Service Bulletin

Bulletin No.: 20-NA-163

Subject: Rearview Camera Displaying Narrow Guidelines and Zoomed Out/Fisheye Appearance

Brand:	Model:	Model Year:		VIN:		Engine:	Transmission:
		from	to	from	to		
Chevrolet	Silverado 2500HD/ 3500HD	2020	2020			All	All
GMC	Sierra 2500HD/ 3500HD	2020	2020

5642270

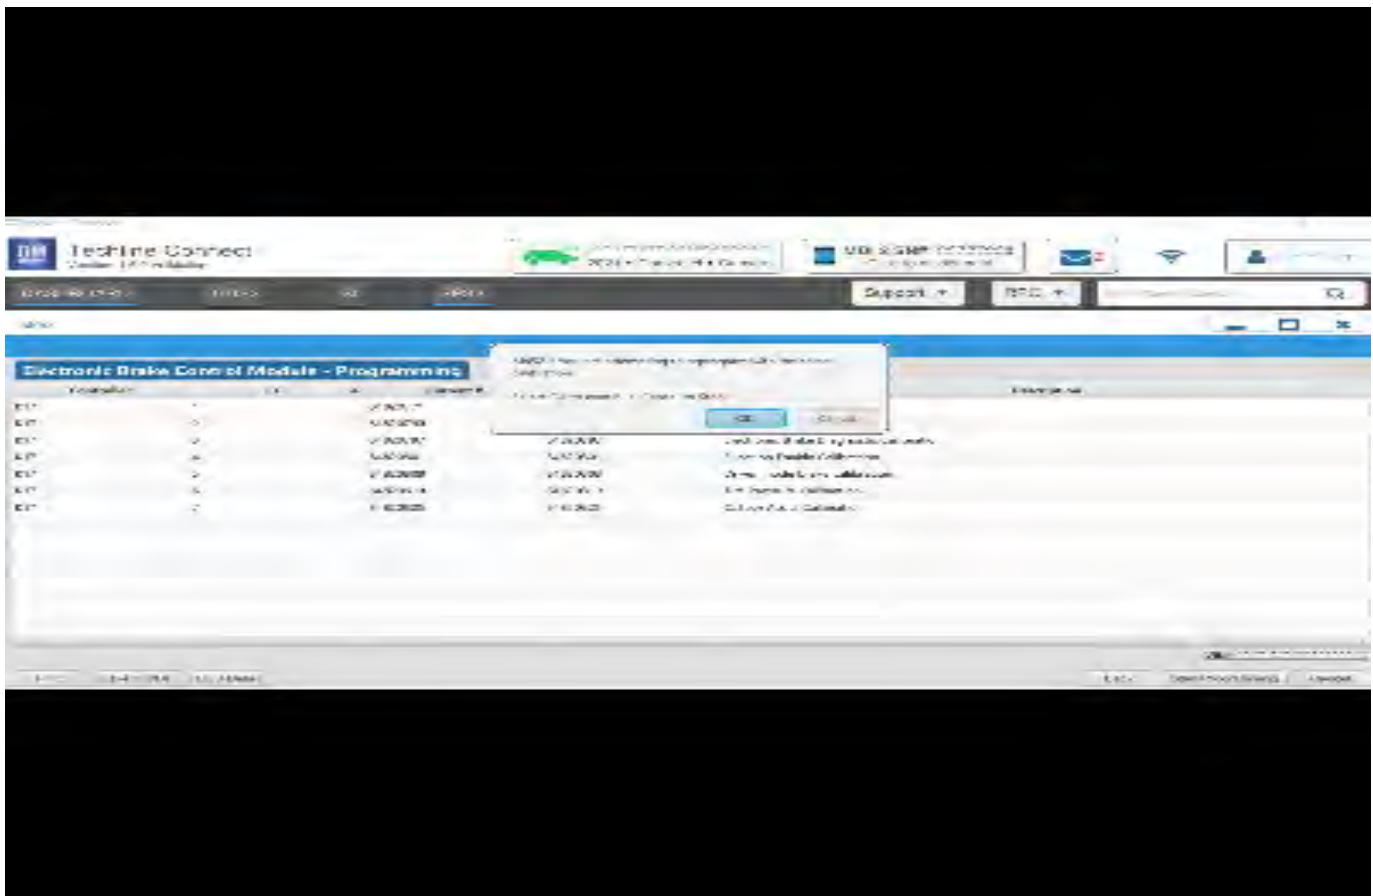
Involved Region or Country	United States, Canada, Mexico, Israel, Palestine, Chile (West), Paraguay (West), Uruguay (West), Thailand (ASEAN)
Additional Options (RPOs)	Equipped with RPO UVI
Condition	<p>Some customers may comment on narrow guidelines and a zoomed out/fisheye appearance from the rearview camera.</p> 
Cause	The cause of the condition may be an issue with the Video Processing Control Module (VPCM) calibration distorting the view from the rearview camera and decreasing the width of the guidelines.

Correction	Utilizing the MDI or GDS/GDS2 tool, verify the VPCM Bootloader P/N is 84809742 then reprogram the VPCM. Follow Service Procedure below. If the VPCM Bootloader P/N is NOT 84809742 (ex. 84650325, 84513776), the VPCM must be replaced with the latest version. Refer to Parts Information and the EPC for the latest VPCM and program with the latest released software.
-------------------	--
